Moon Roof - Creak Noise

NV008-01

MOON ROOF CREAK NOISE

'00 Celica

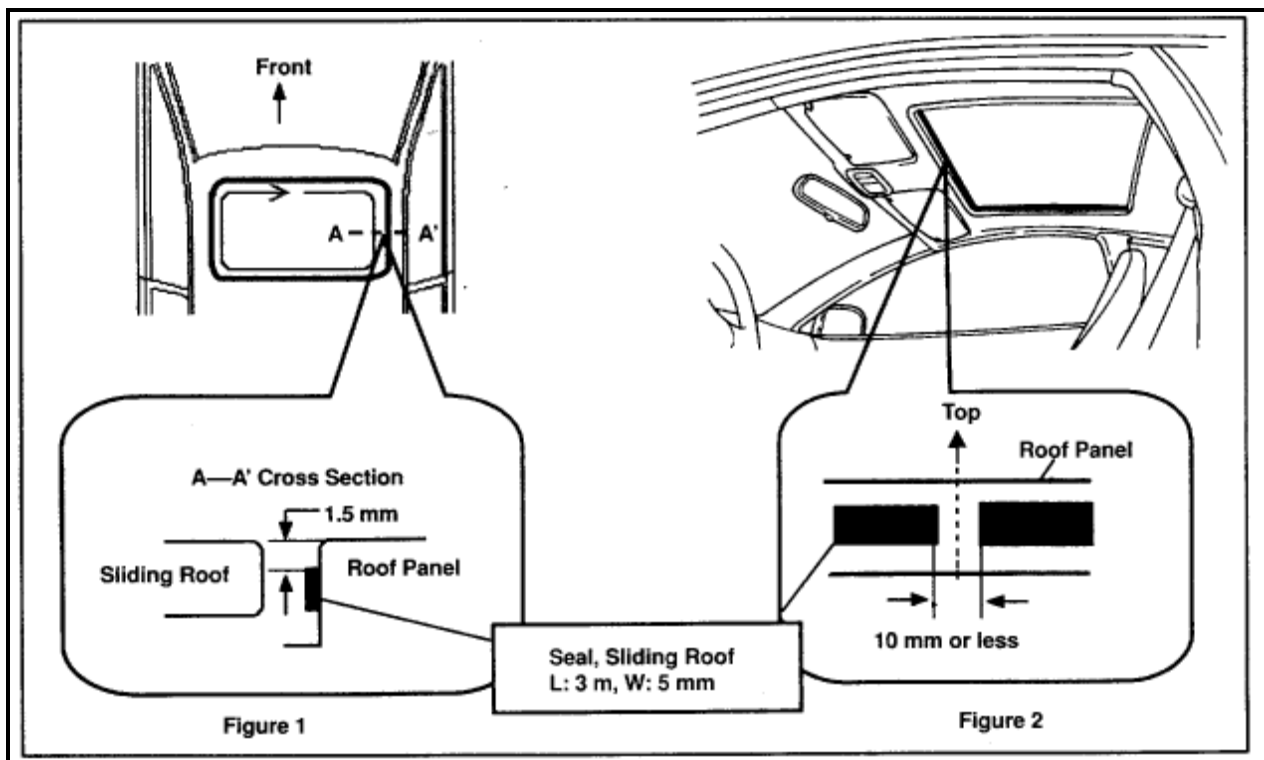
Applying position of the Seal to roof panel top surface - 1.5 mm (See Figure 1).

- a. Keep the [Sliding Roof](#) Seal lightly stretched when applying it.

Do not, however, stretch the [Sliding Roof](#) Seal when applying it to the corner of the roof panel.

- b. Cut the [Sliding Roof](#) Seal so that the gap will be 10 mm or less and the ends may not overlap (See Figure 2).
- c. Press the [Sliding Roof](#) Seal to let the air out of it.
3. Clean the outside of the moon roof weatherstrip.
